### PLANNING COMMISSION

June 9, 2025

Brandon Rotary Glass SITE & DIMENSION PLAN

Subject: 901 N. US-127 Site Plan Review

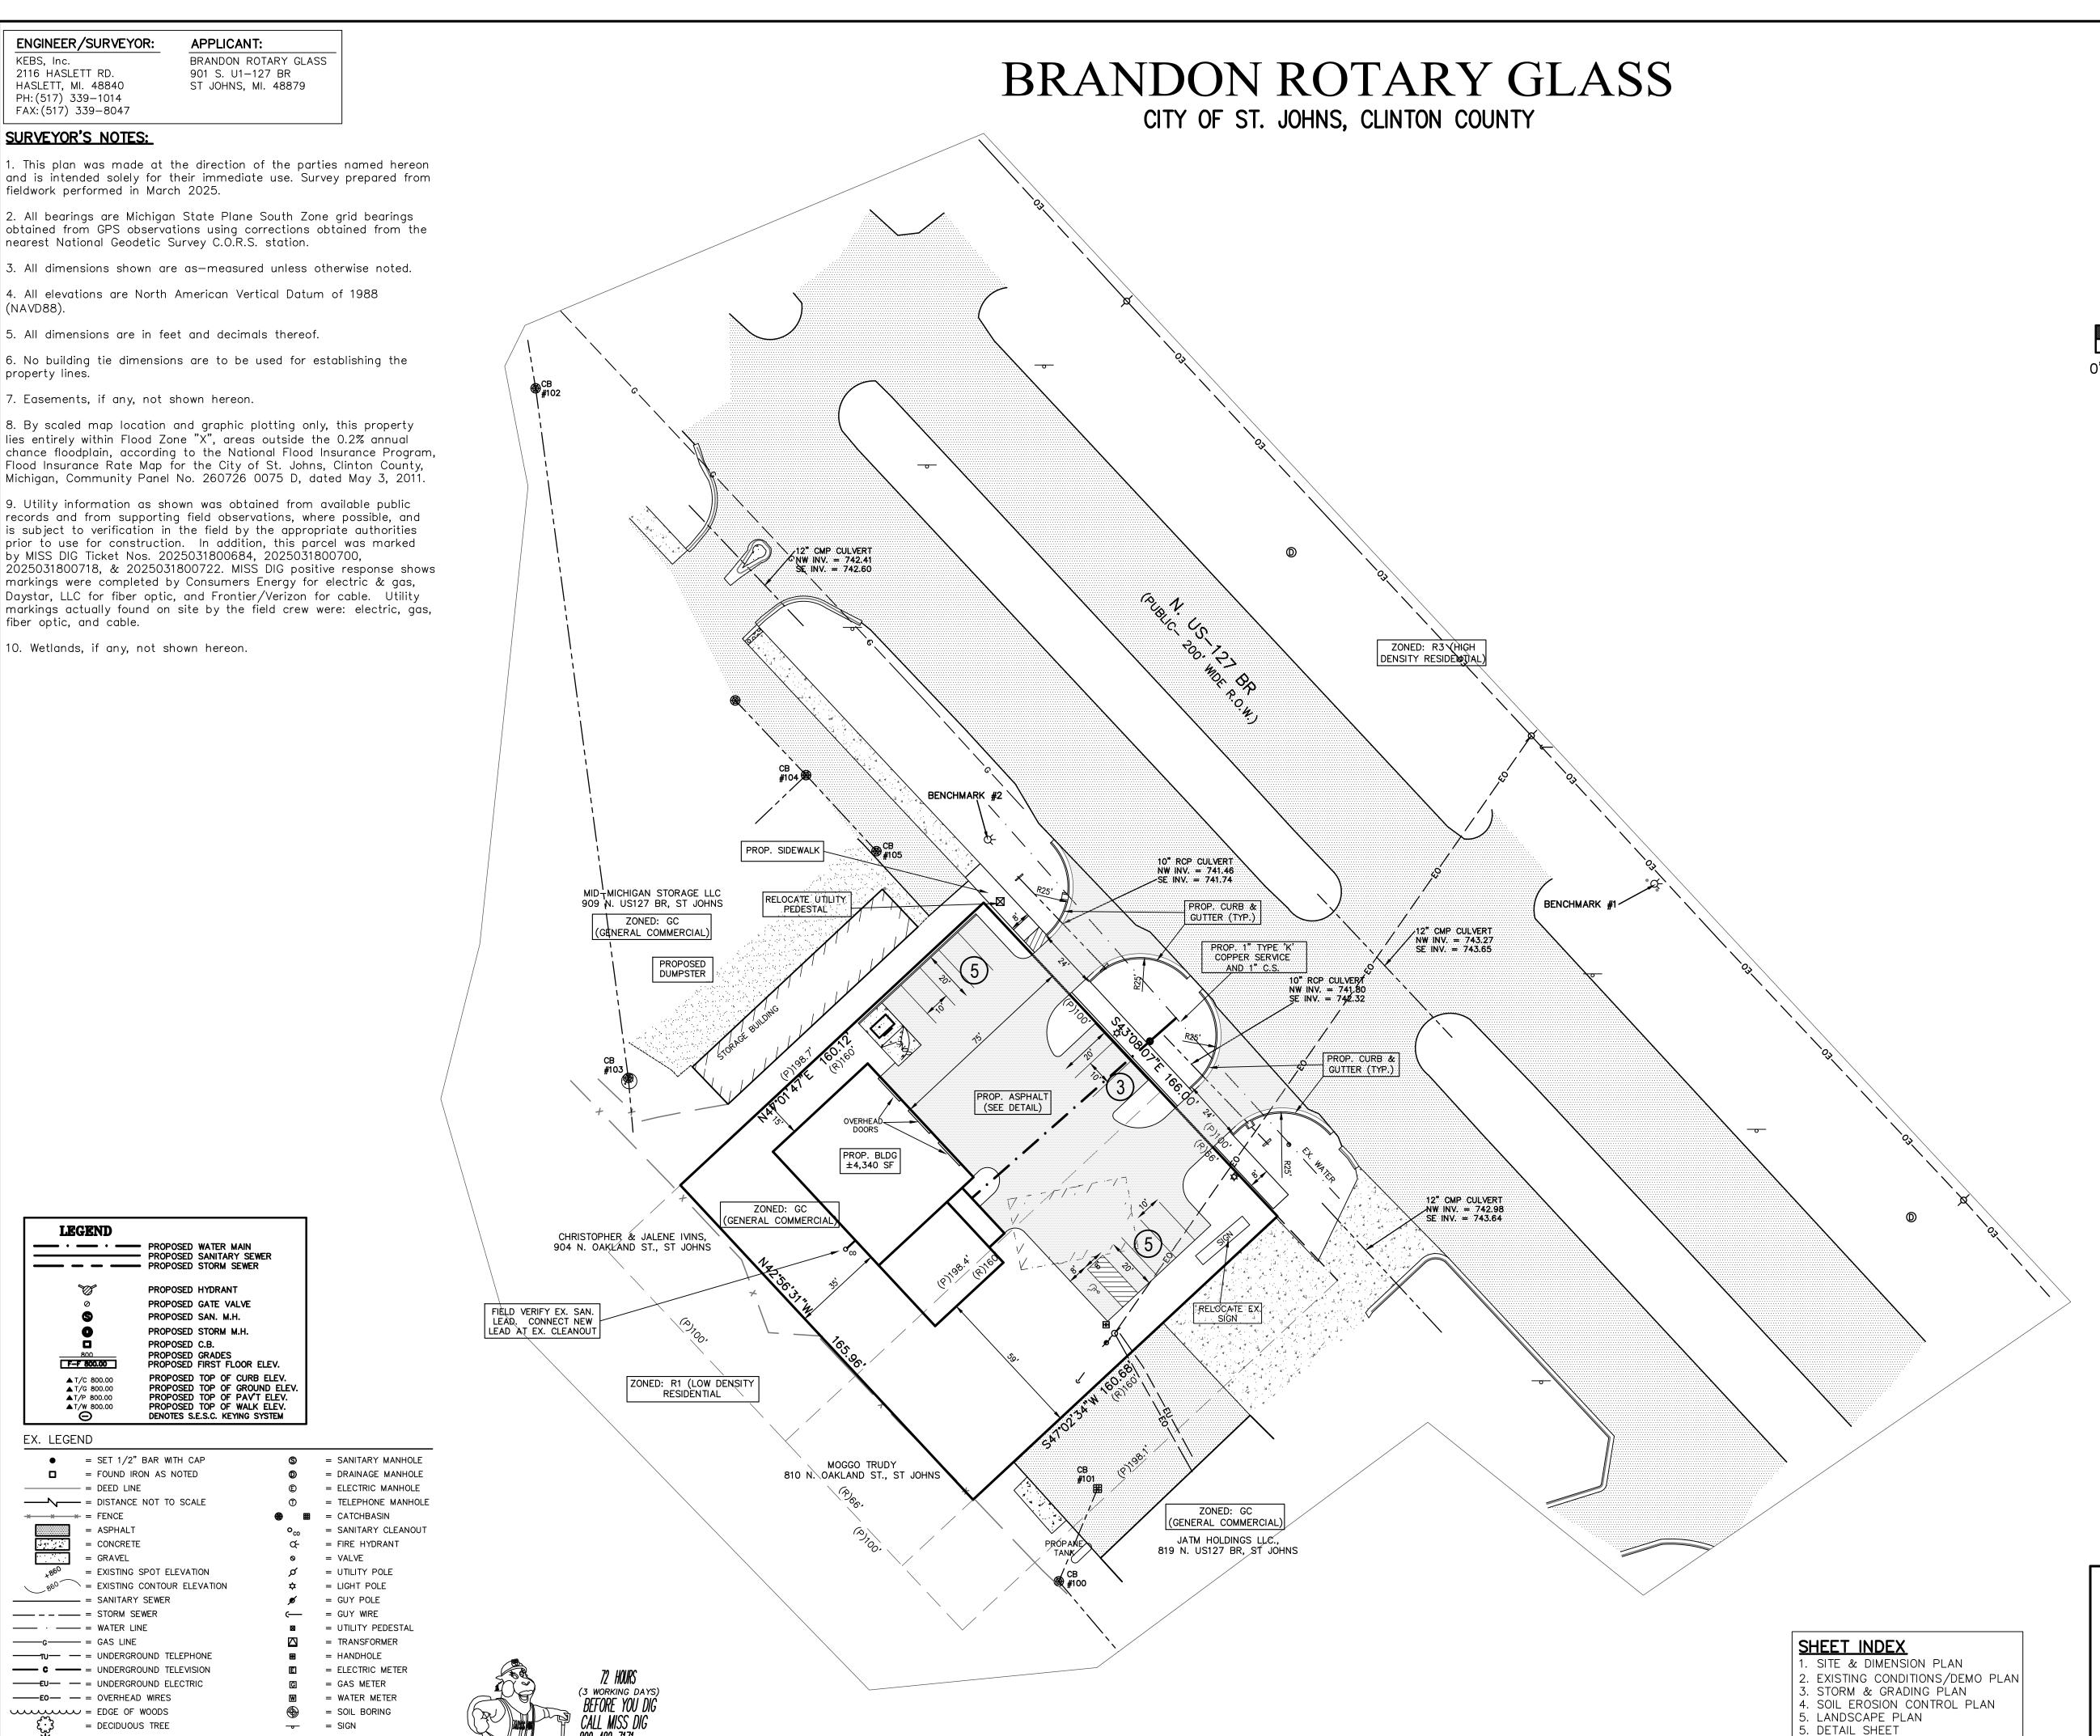
- b. **Barrier-Free Spaces.** ADA regulations require parking lots with 1-25 spaces to provide one (1) accessible parking space. The plan identifies one (1) barrier-free space, which is in accordance with ADA dimensional standards.

- c. **Dimensions.** The Site Plan confirms that all new parking spaces will be 10 feet wide and 20 feet deep, as required in the Zoning Ordinance.
- d. **Paving and Striping.** The Site Plan shows the limits of all proposed paving for the site, which complies with the requirements of the Zoning Ordinance.

- e. **Loading Spaces.** Section 155.344.B of the Zoning Ordinance states that all retail uses must provide one loading zone for every 20,000 square feet of building area above 5,000 sq. ft. The proposed building is approximately 4,340 square feet in area, which does not require any dedicated loading area for the site.

- f. **Pedestrian Access.** Section 155.201 of the Zoning Ordinance requires a sidewalk, at least five feet in width, to be installed along the street frontage of any property whenever any site plan approval is required. The applicant is proposing a sidewalk along the US-127 BR frontage that connects to the existing sidewalk along the parcel to the Northwest. The 8-foot proposed sidewalk will comply with the requirements of the Zoning Ordinance.

Brandon Rotary Glass LANDSCAPE PLAN

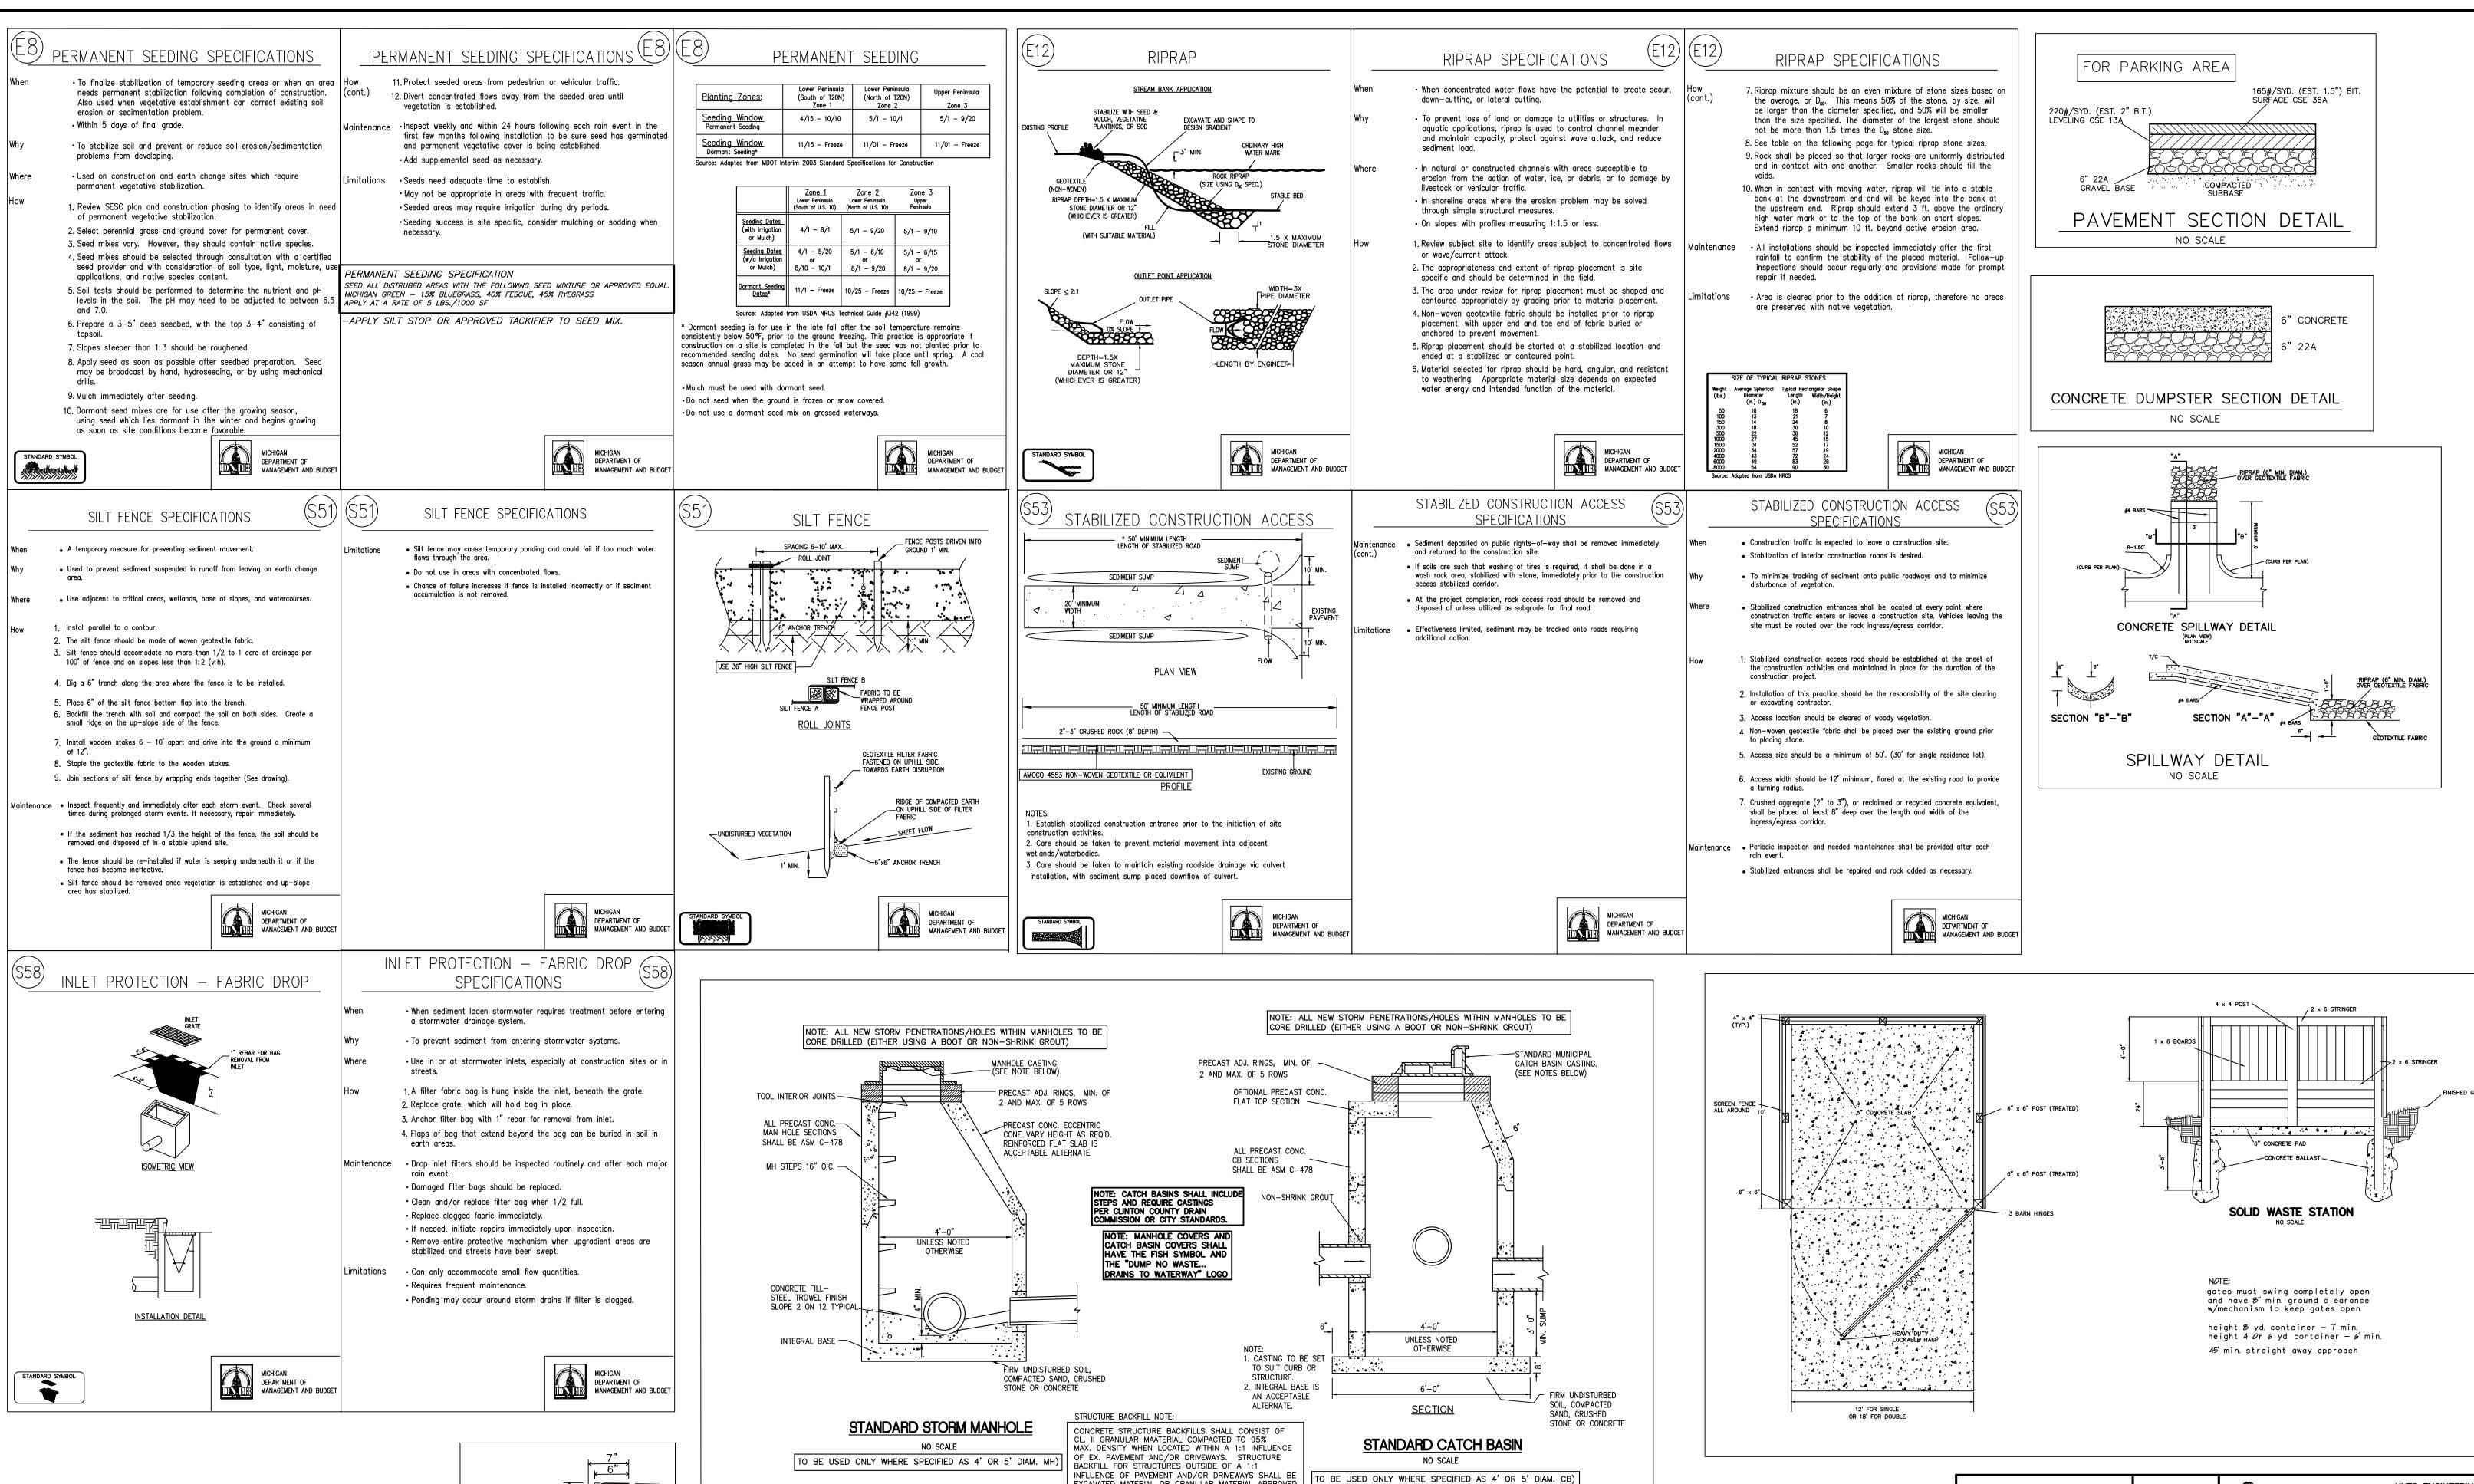
- a. Buffer Zone. Table 10-1 outlines buffer zones from all uses. Parcels in the GC District must provide a buffer zone between all residential uses. Each buffer zone is required to contain two (2) trees and four (4) shrubs per every 25 lineal feet of property line adjacent to a residential district. Alternatively, the applicant may install a buffer wall that meets the standards of Section 155.297.E of the Zoning Ordinance. As the rear lot line abuts R-1 zoned properties, the length of the 166-foot lot line must include at least 14 trees and 28 shrubs or a buffer wall along the entire length of the rear lot line.

The applicant is proposing ten (10) new Green Giant Arborvitae plantings in addition to the approximately 24 existing trees and 12 existing shrubs along the rear lot line, plus the existing wood fence. In order for the wood fence to be considered a sufficient "buffer wall," it must meet the following requirements, from Section 155.297.E:

- 5. Walls must be maintained in good condition by the property owner. The fence is existing, and it is not clear who owns it or maintains it. Some portions are showing signs of deterioration, as referenced in the attached images. We recommend that the Planning Commission consider the existing fence and abundant landscaping along the property line sufficient to meet the screening requirements of the Zoning Ordinance.

- d. Landscaping Adjacent to Buildings. Section 155.302 requires a landscape area equivalent to 10% of the area of the principal structure to be constructed along the walls for GC zoned properties. There appear to be no proposed plantings adjacent to the proposed building. The

At the June 9<sup>th</sup> Planning Commission meeting, the Planning Commission should decide whether the proposed landscaping is sufficient. Following that discussion, we recommend *CONDITIONAL APPROVAL* of the Site Plan, with the following conditions:

- 1. The applicant submits a revised landscape plan that details the required 434 square feet of landscape area adjacent to the proposed building.
- 2. The applicant submits a photometric plan detailing all exterior light fixtures and their illumination levels across the entire property to ensure no light trespasses on adjacent properties.
- 3. The applicant receives approval from the City Engineer for stormwater management.

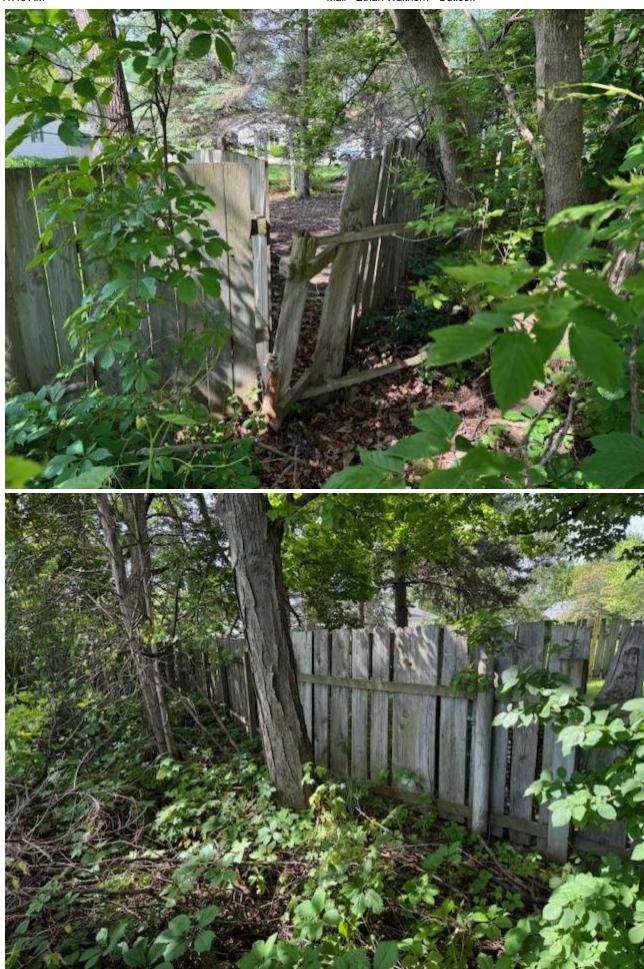
Here are some pictures of the fence that stretches along the entire west border of the property.

The pictures are viewed from my side of the fence. Hopefully all the existing trees and shrubs can be considered while satisfying the landscaping requirements.
